Response to "Supplemental Appeal Brief"

Serial No: 10/005,682

For: Glass Container Forming Machine

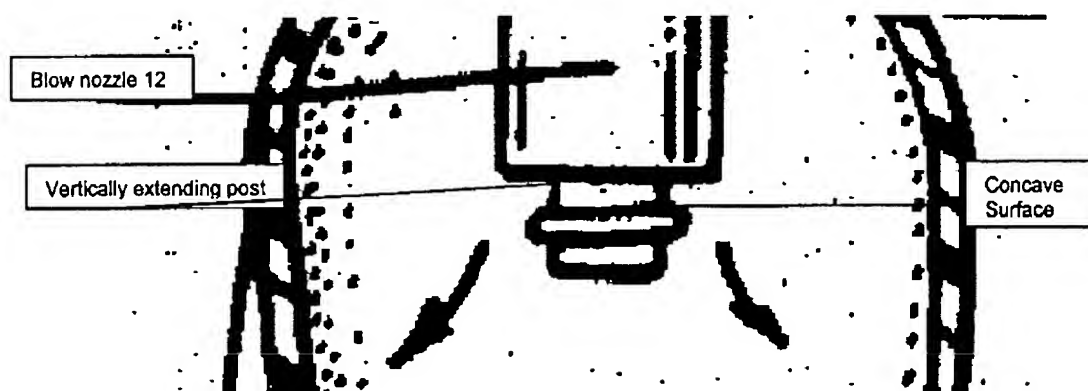
Claims 1-2 and 4 are rejected under 35 U.S.C. 103(a) as being unpatentable over Rodriguez-Wong et al US 5,807,419 ('419) in view of Virog Jr. US 4,348,167 ('167). Rodriguez-Wong discloses a glass-forming machine in order to shape a glass parison in a blowing mold (Abstract). The claimed "a blow head assembly" is '419 element 50. The claimed "support means for supporting said blow head assembly" is deemed as lock 52 of Rodriguez-Wong disclosure. The "first displacement means for displacing said support means to displace said blow head assembly between a remote up position and an advanced down position" is shown by '419 as piston element 56. The claimed blow tube displaceable between an up and down position is shown by Rodriguez-Wong as element 30. The second displacement means for displacing said blow tube from the up position down to the down position is deemed as '419's cylinder piston assembly 20. Rodriguez-Wong is silent disclosing the blowing nozzle with an "air deflector having an annular, concave surface terminating at the top with a vertically extending post for deflecting air traveling axially down the blow tube uniformly radially outwardly." However, Virog Jr discloses a conventional blowing nozzle, element 12, as shown in figure 1 having an annular air deflector with concave surface terminating at the top with a vertically extending post. As noted by Virog, air is

blown into the mold to force the parison against the inner walls of the mold and/or in order to help maintain the shape of the parison air is blown outwardly against upper edge of the parison (See Col. 1, lines 14-18 and 28-30). Thus in view of the teachings of Virog showing a conventional blow tube means having an annular air deflector with concave surface terminating at the top with a vertically extending post, a person of ordinary skill in the art at the time the invention was made would have been motivated to provide Rodriguez-Wong glass-forming machine with Virog Jr conventional blow tube in order to provide outwardly flow of air to maintain the shape of the parison as taught by Virog Jr.

Additionally, in regards to the claimed supporting frame, it would be expected that Virog Jr. provides a frame to hold the air deflector from falling down.

Applicant also argues that Virog does not disclose an annular concave surface. Said argument is found unpersuasive. As shown in the figure above, which is a blow up of the nozzle 12, it explicitly shows a concave surface formed by a doughnut shaped ring annular to the vertical extending post.
